# Access Compliance Report

## Public Rights-of-Way

Intersection ID: 13197	Main Street: S_MCDOWELL_ST	Cross Street: E_4TH_ST	Location: N
ADA ID: 3A13894D9698	Ramp Type: Para	Initial Pass/Fail: Fail	Overall Compliance: No
Severity Score: 21.25			
Codes/Mitigation Info/Possible Solution		Field Measurements/Component Compliance

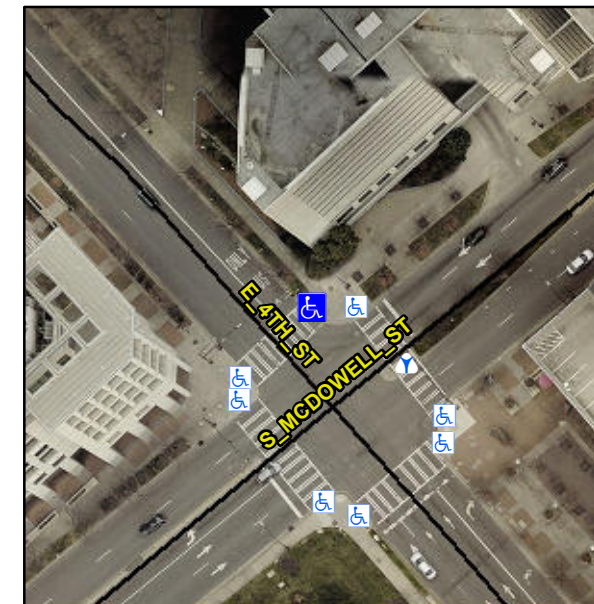
**Remove & Replace Entire Ramp.**

**R304.5.1, R304.5.3**

Compliance	Description	Data	Compliance	Description	Data
N/A	Ramp Length LT (in)	68.0	N/A	Ramp Length RT (in)	61.0
Yes	Ramp Width LT (in)	74.0	No	Ramp Width RT (in)	44.0
Yes	Ramp Slope LT (%)	7.3	Yes	Ramp Slope RT (%)	5.7
No	Ramp XSlope LT (%)	3.3	No	Ramp XSlope RT (%)	6.7
N/A	Landing Length (in)	N/A	N/A	DWS Provided?	N/A
N/A	Landing Width (in)	N/A	N/A	DWS Contrast?	N/A
N/A	Landing Slope (%)	N/A	N/A	DWS Length (in)	N/A
N/A	Landing X Slope (%)	N/A	N/A	DWS Full Width?	N/A
N/A	Landing Curb? (Y/N)	N/A	N/A	DWS Offset (in)	N/A
N/A	Shared Landing?	N/A			
N/A	Gutter Ponding?	N/A	N/A	Gutter Slope (%)	N/A
N/A	Gutter Lip Ht (in)	N/A	N/A	Gutter X Slope (%)	N/A
N/A	Painted X Walk1?	Yes	N/A	Painted X Walk2?	N/A
	X Walk 1 Direction	To SW		X Walk 2 Direction	N/A
N/A	X Walk 1 Width (in)	177.0	N/A	X Walk 2 Width (in)	N/A
	X Walk 1 Slope (%)	3.4		X Walk 2 Slope (%)	N/A
	X Walk 1 X Slope (%)	1.3		X Walk 2 X Slope (%)	N/A
N/A	Ramp inside XWalk1?	Yes	N/A	Ramp inside XWalk2?	N/A
